## Development Review Division

**DATE:** Feb. 26, 2021

**SUBJECT:** SP20-131 Site Plan – Planning Review 1

**LOT 6 PARKER AND PINE FILING 1**  
 PARKER, CO  
 EVERBROOK ACADEMY SITE PLAN  
 SITE PLAN

LOT 6 PARKER AND PINE FILING 1  
PARKER, CO  
EVERBROOK ACADEMY SITE PLAN  
ARCHITECTURAL ELEVATIONS

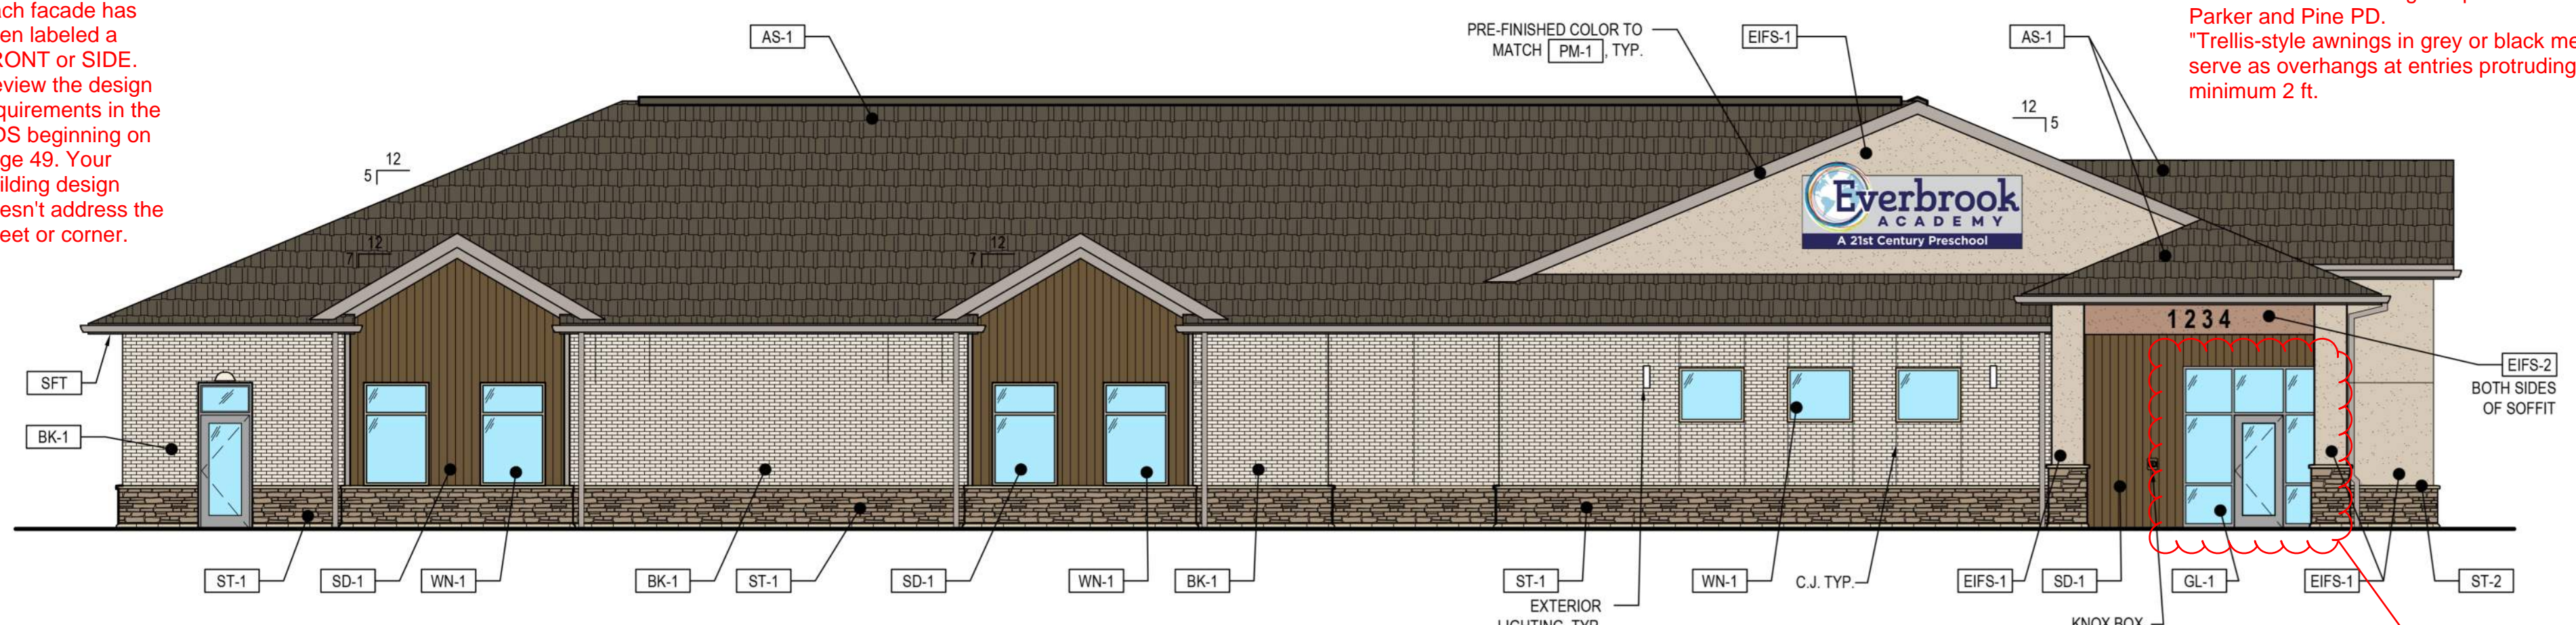
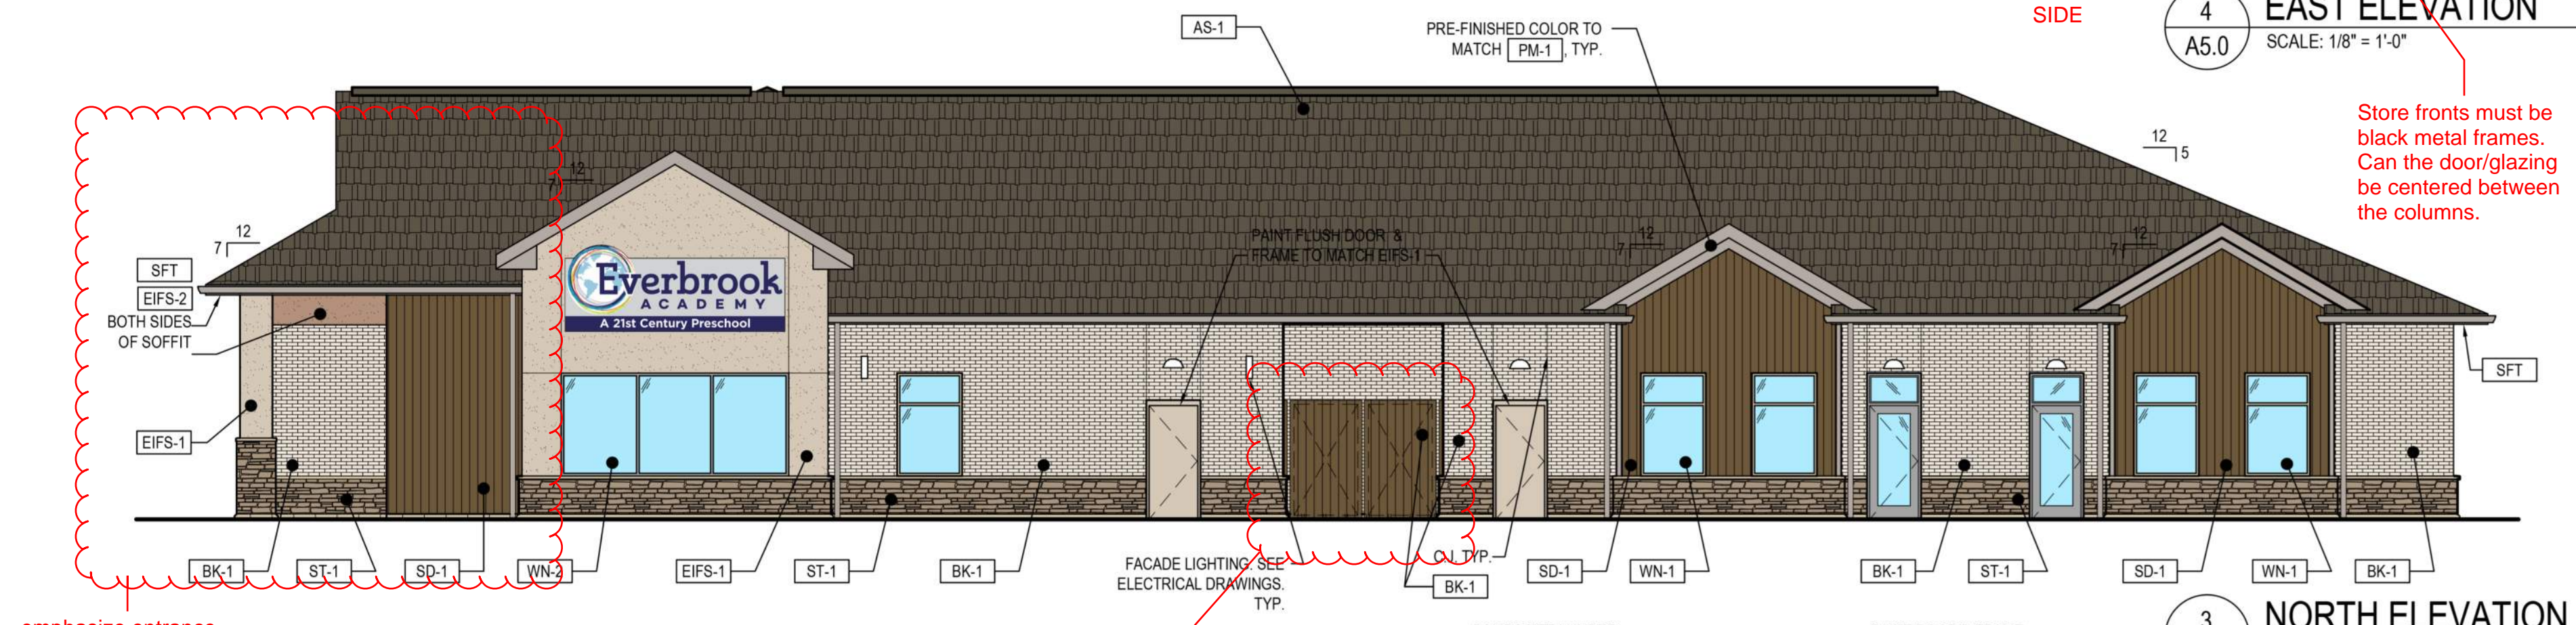
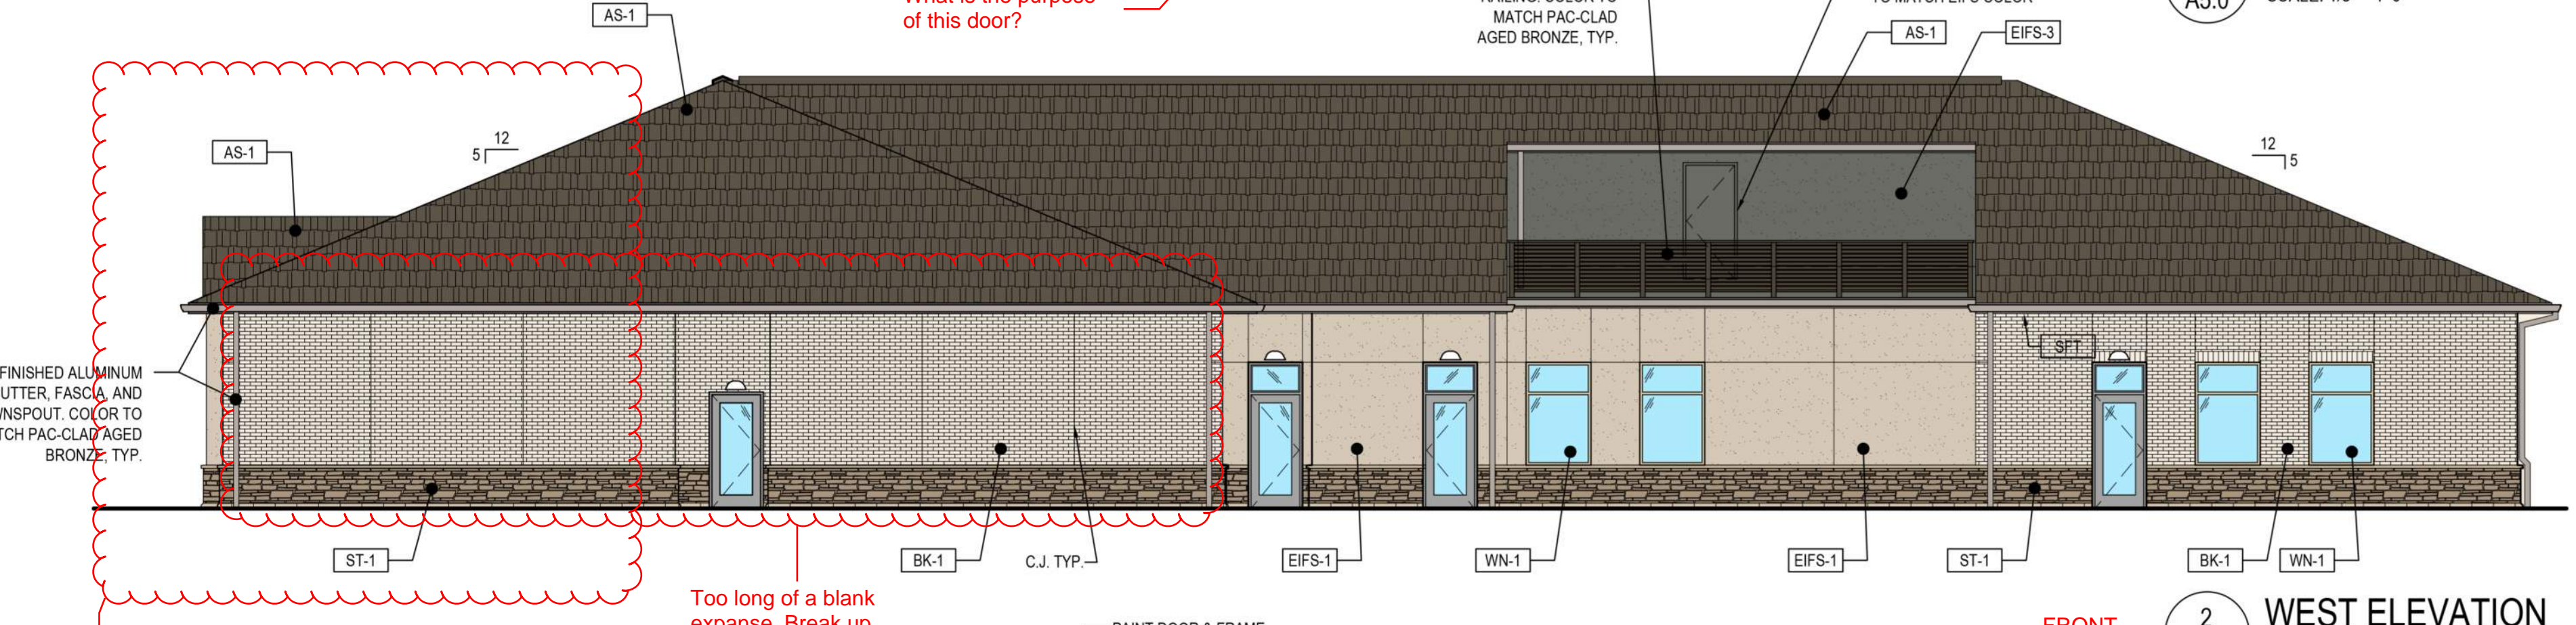
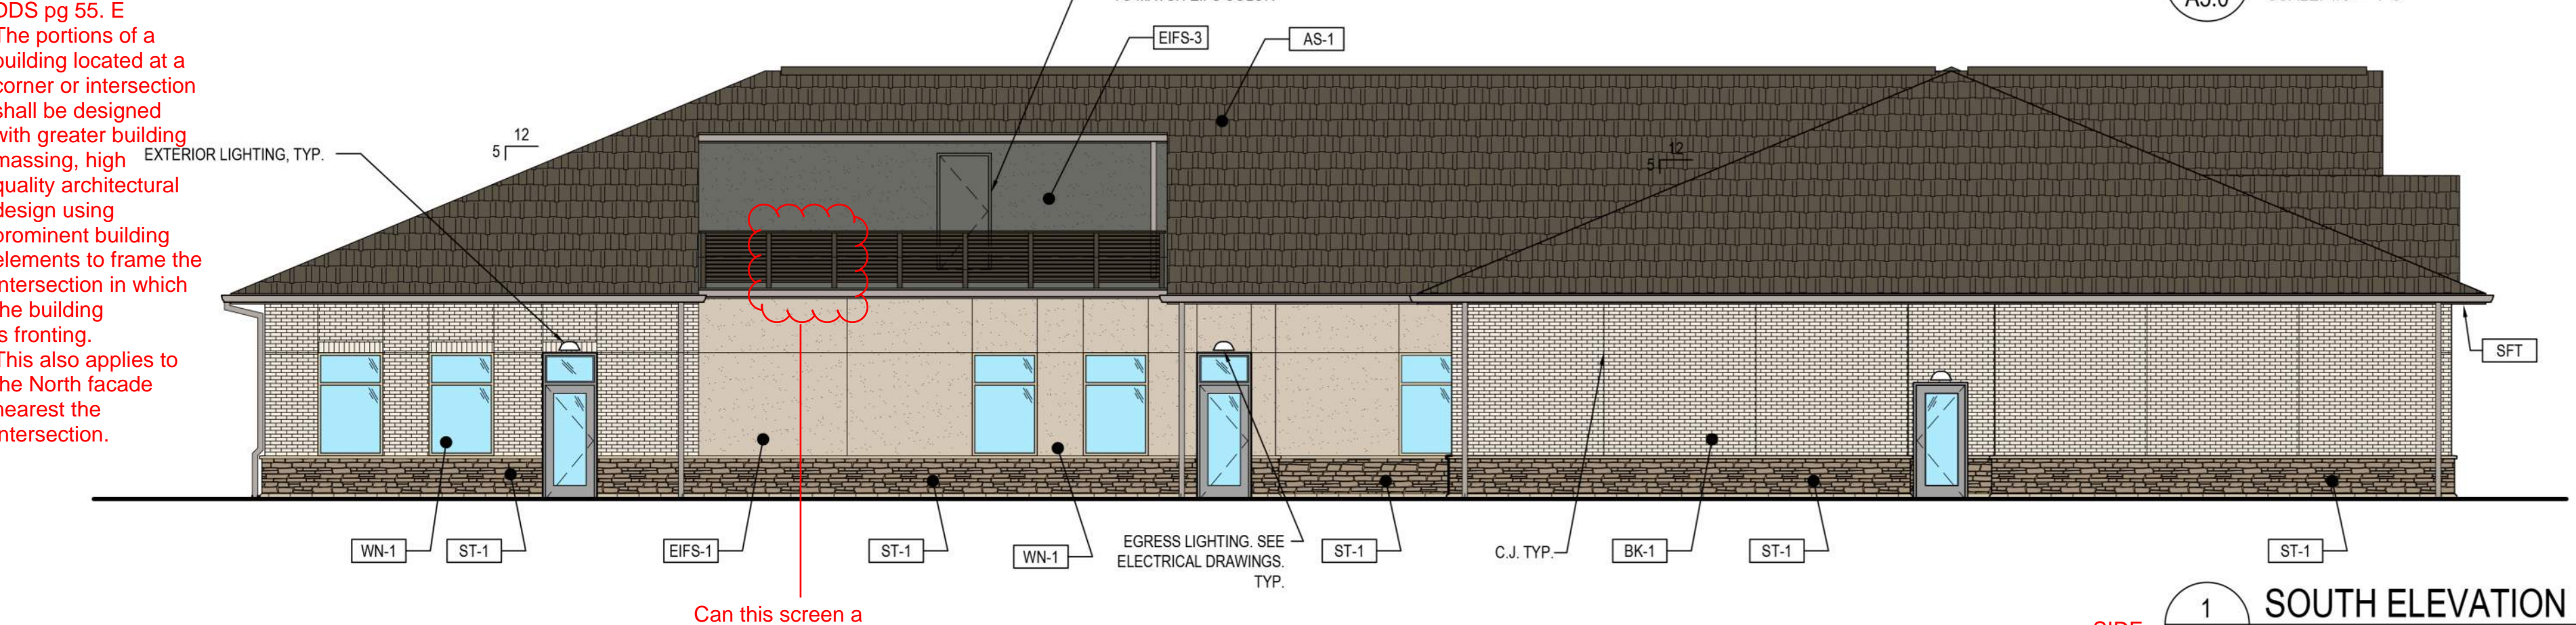
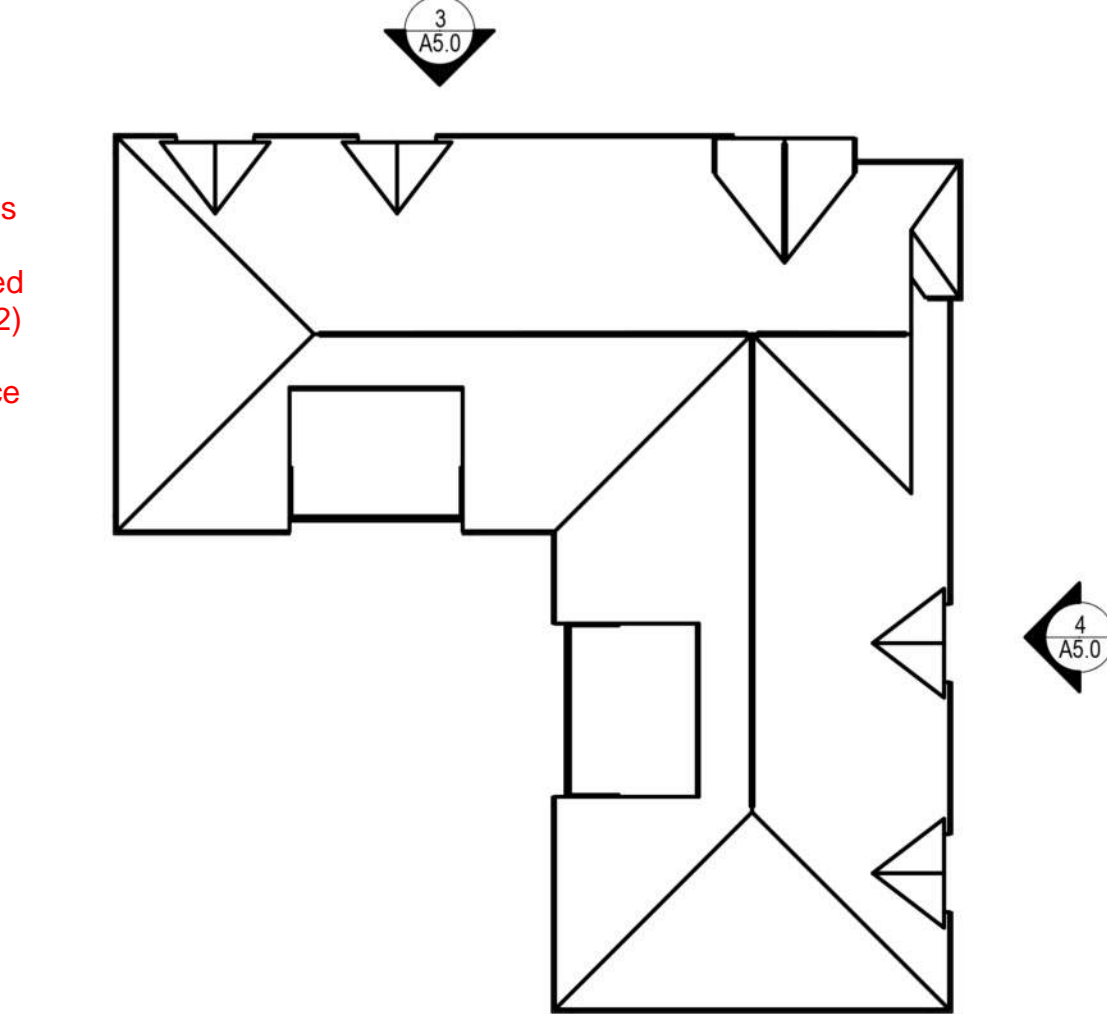
Each facade has been labeled a FRONT or SIDE. Review the design requirements in the DDS beginning on page 49. Your building design doesn't address the street or corner.

Please review the design requirements of the Parker and Pine PD. Trellis-style awnings in grey or black metal will serve as overhangs at entries protruding at minimum 2 ft.

DDS page 57. 1. Front and Side Facades  
a. All front and side building facades that face a public roadway shall include a minimum of two (2) of the following building elements (see figures 81 and 82):  
i. Awnings  
ii. Canopies  
iii. Arcades  
iv. Galleries  
v. Tower elements  
vi. Prominent roof feature

Your north side only has prominent roof features. The west side has no architectural detailing.

draw to scale, provide scale.

Call out locations of all RTUs. Is the screening fence tall enough to fully screen all RTUs? Will any be wall mounted? show location of any wall mounted utilities.

Provide a 3d rendering to show how wall setbacks align with roof changes. Provide multiple perspectives, but especially from the North/east and SouthWest angles.

emphasize entrance

What is the purpose of this door?

Too long of a blank expanse. Break up

DDS pg 55. E The portions of a building located at a corner or intersection shall be designed with greater building massing, high quality architectural design using prominent building elements to frame the intersection in which the building is fronting. This also applies to the North facade nearest the intersection.

Can this screen a RTU?

DDS pg 55 D Articulation and detailing is required where the roof meets the wall using cornices, eaves, or rakes as detailing. Moldings, brackets, exposed rafters of at least twelve (12) inches and finials shall be used to give the roof/cornice proper visual weight and proportion to the building (see figure 76).
